## CONSERVATION INSPECTION AND ASSESSMENT FOR THE PROPOSED RENOVATION AND CHANGE OF USE OF THE BREWHOUSE AT ST FRANCIS ABBEY BREWERY, KILKENNY.

## Redevelopment of The Brewhouse St Francis Abbey Brewery, Horse Barrack Lane, Irishtown, Kilkenny

**Conservation Architect Report**

Interior View of the boiler house of phase 4 with the brick exterior to the North Elevation. The North elevation is to the right of the picture defining the threshold between interior and exterior.

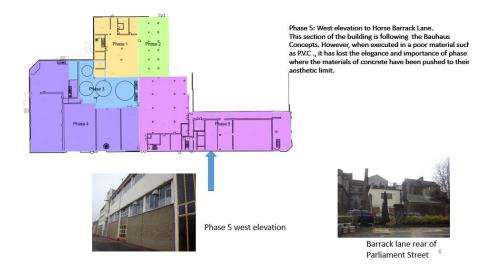
There is a huge opportunity to create an interactive innovative space allowing interaction between interior activities and the exterior public space reconnecting the building back to the city and allowing an urban space to develop in front of the Abbey. It is proposed to lower the floor to ensure the connection between inside and out.

Detail of the East elevation showing the new roof terrace overlooking St. Francis Abbey .

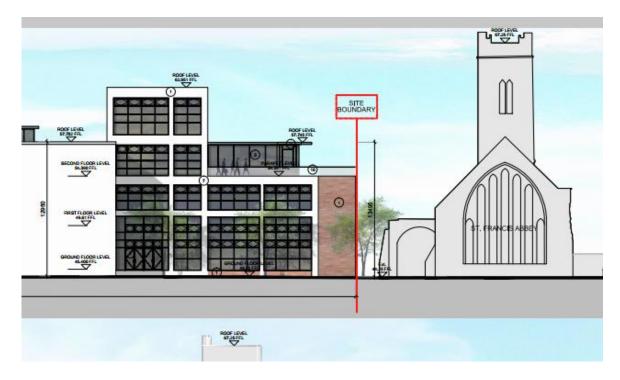
The mono pitch roof lights are to be low so that they are only visible from a distance. The material of the roof lights is opal glass so that the impact of the roof lights is minimized at night. The opal glass serves two purposes in that it also reduces glare during the day. The design of the roof lights should be recessive to the main structure.

There is an opportunity to allow a glazed extension on the roof provided that the single storey extension is set back from the North Elevation ensuring a viewing platform. The line of this new light weight glass structure is naturally defined by the grid structure of the east elevation and should not be permitted past this point.

No mechanical plant room or mechanical plant should be permitted on the roof where it can be viewed from either the Green Bridge or from the west side of the building.

In particular with regard to the visual impact of the Brewhouse behind the Abbey when viewed form Green's Bridge. The roofscape is visible from St Canice's tower and also from various other strategic points in Kilkenny.

The fenestration for the new windows should echo the design concept of the Bauhaus principles. It is recommended that the bays be divided into four columns of symmetrical evenly sized rectangular windows and that the top two sections of the rows are side hung thus creating a vertical wave when open. This also complies with the mechanical requirements for ventilating the rooms as requested by the mechanical engineers. The proposed windows should not be top hung.

The brick panels to the bottom of phase 4 the boiler house are to be removed as the internal floor of the boiler house is to be lowered thus allowing a connection from the interior of the renovated boiler house to the exterior space. There is to be a raised access floor to be installed here to allow full flexibility of this space.

The higher section of the brick parapet is to be lowered to reinstate the uniform level of the parapet dictated by the North Elevation.

A section of the blue tiles and the blue colour scheme of the structure should be retained,
